UT to Mill Swamp Restoration Project Seventh Monitoring Measurement Sixth Year of Credit Release - Final

Onslow County, North Carolina

DMS Project ID Number – 95019, DEQ Contract No. 003992

Subject: Task 12: Response Letter to DMS review comments regarding the Draft Year 6 Monitoring Report for the UT to Mill Swamp Restoration Project (#95019)
White Oak River Basin – CU#03030001, Onslow County, North Carolina
DEQ Contract No. 003992, Baker No. 124578

Figure 2 Index Map
Current Condition Plan View
Monitoring Year 6
UT to Mill Swamp Site

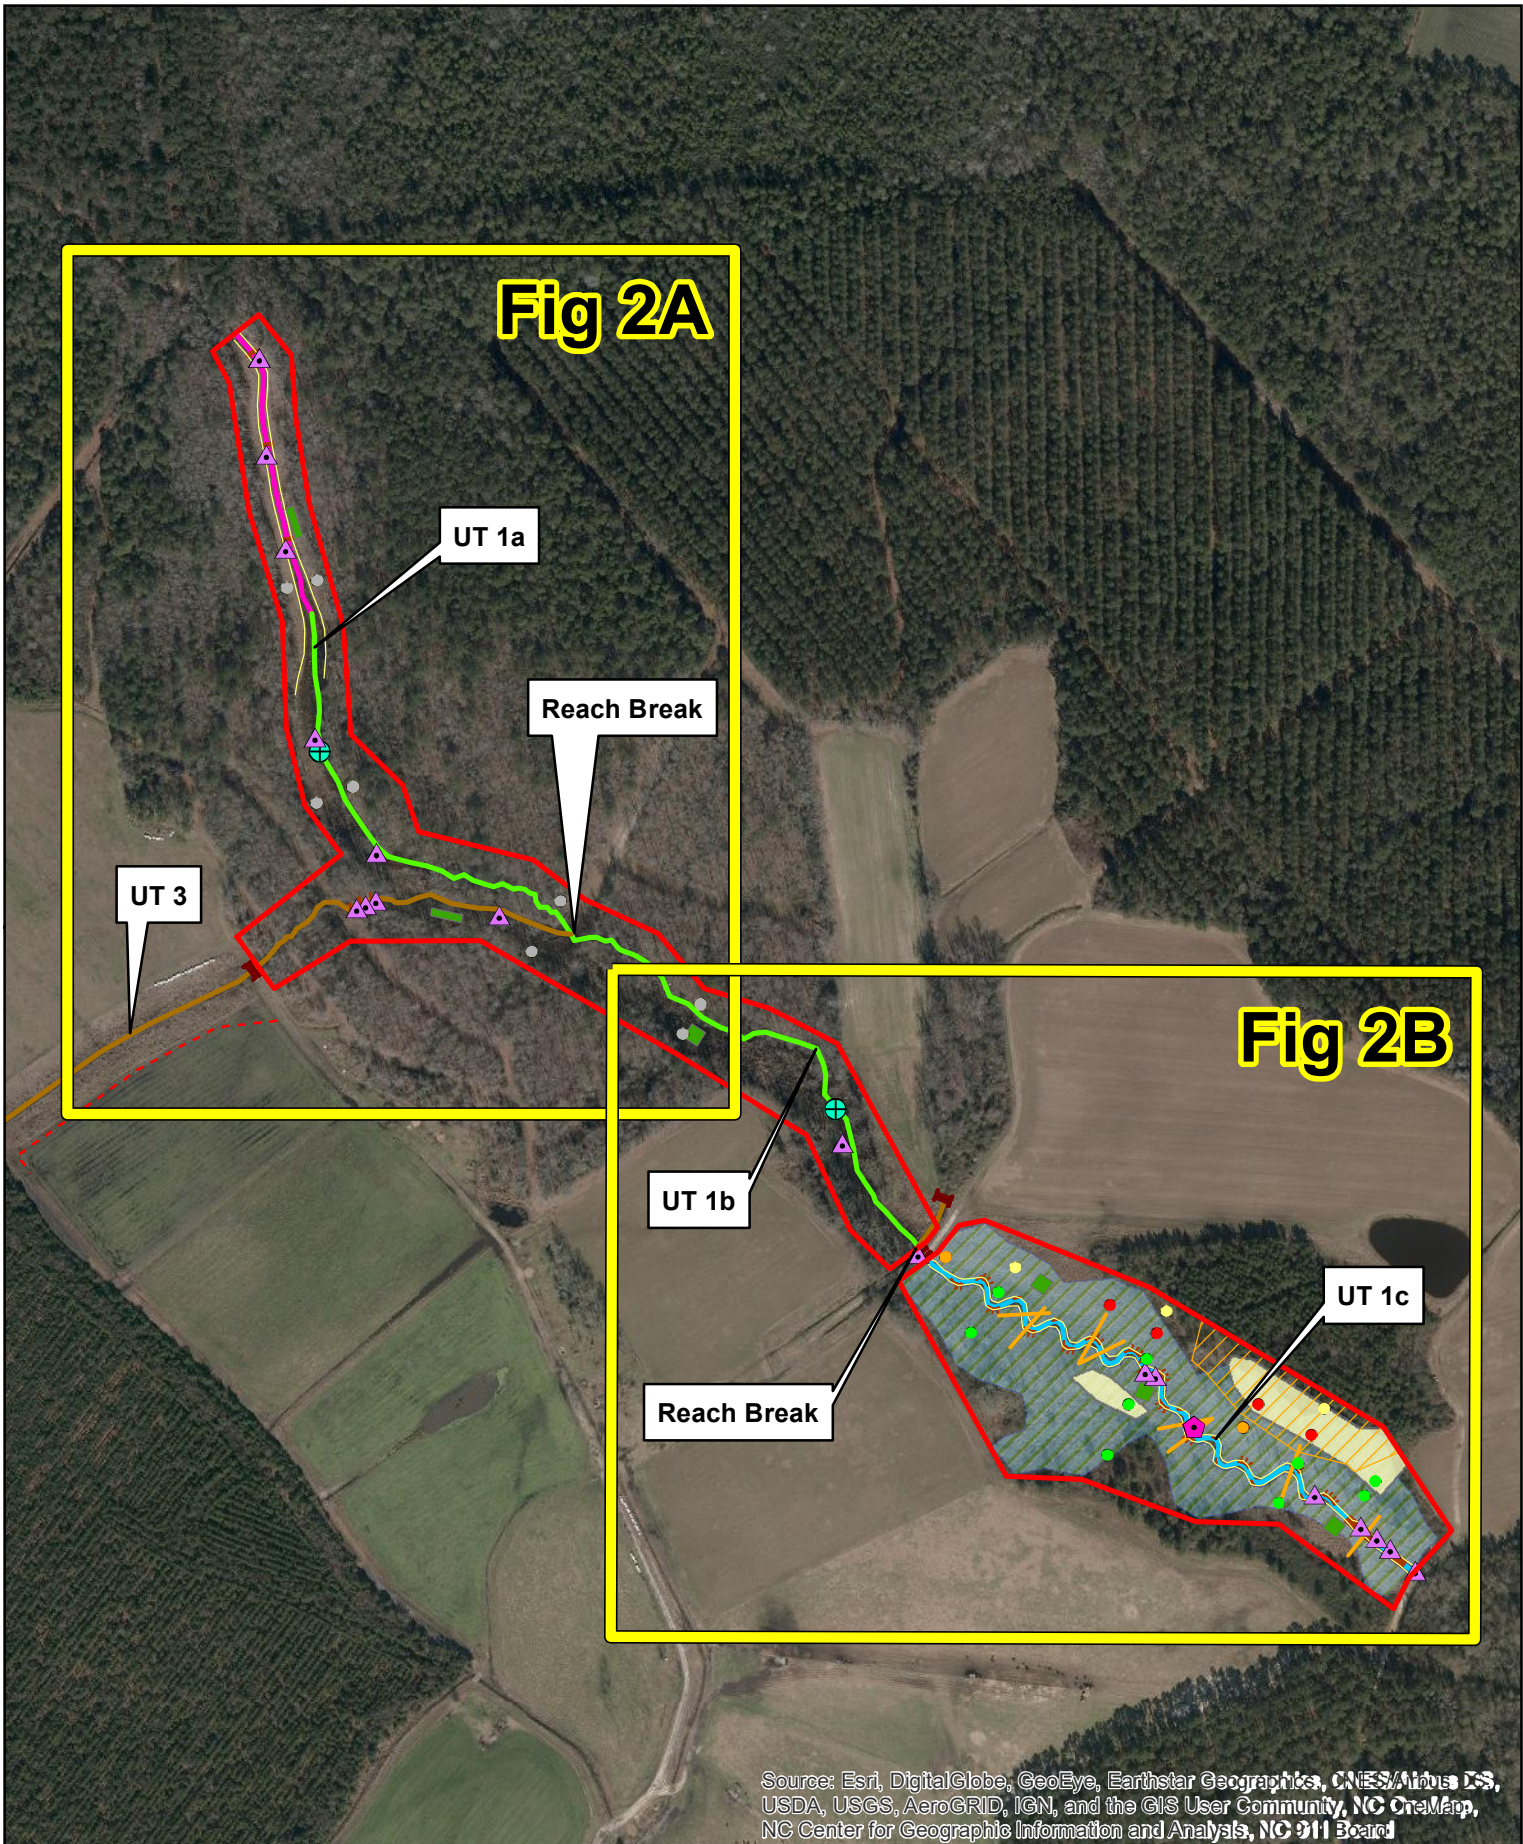
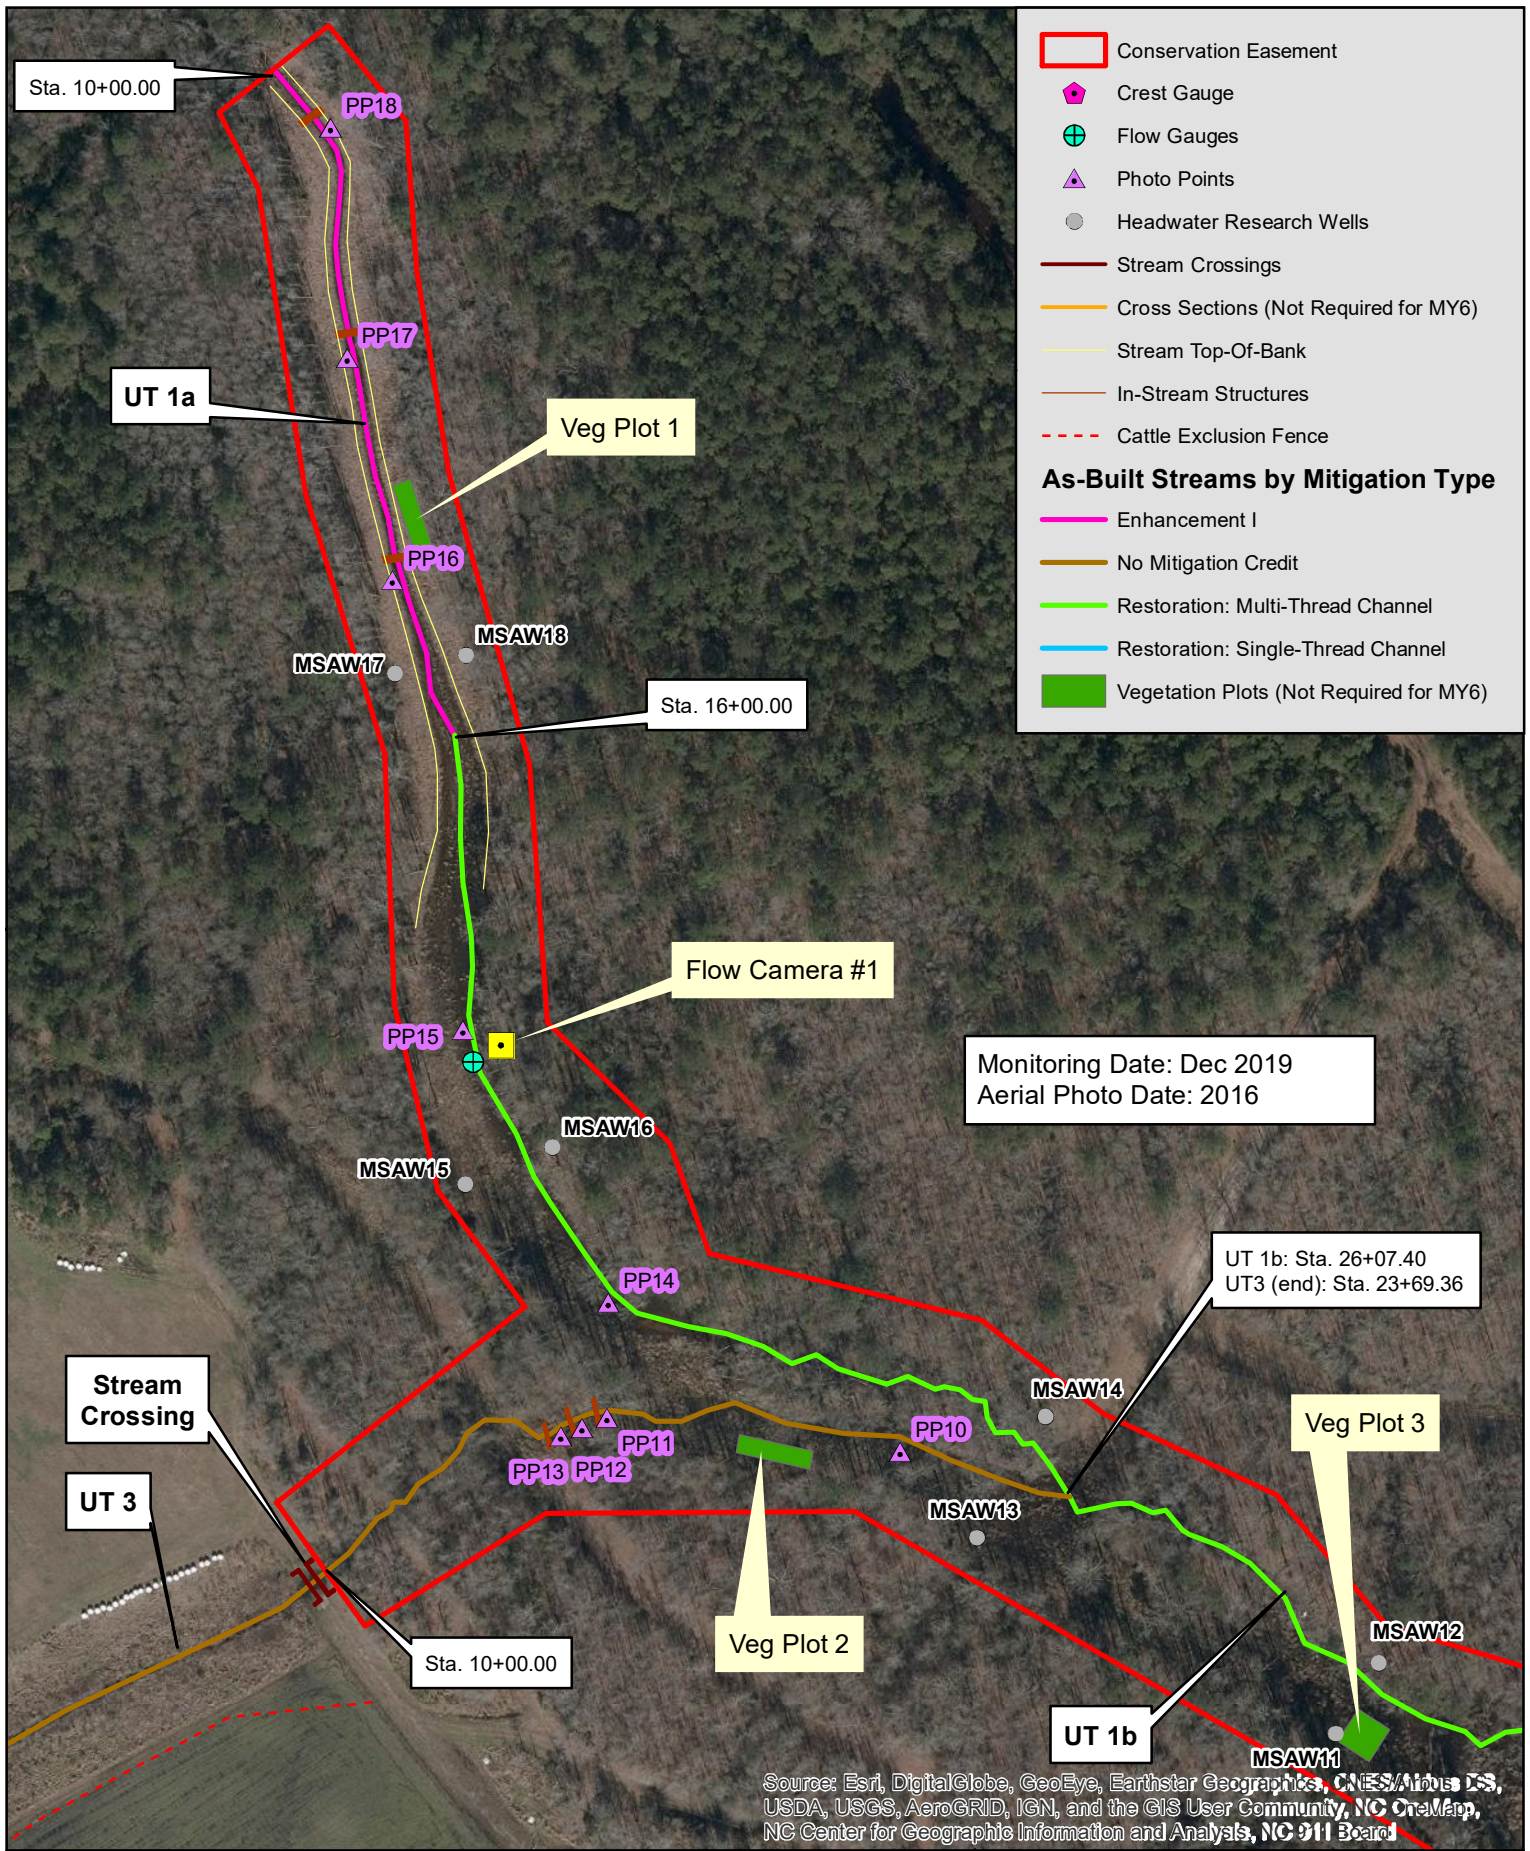
- a. Figure 2A: Please label the photo points with their assigned numbers.
- b. Figure 2B: Please add the gauges colored yellow to the legend.
- c. It would be helpful to indicate the location of Flow Camera #1 on the CCPV.

Response: Revisions made as requested.
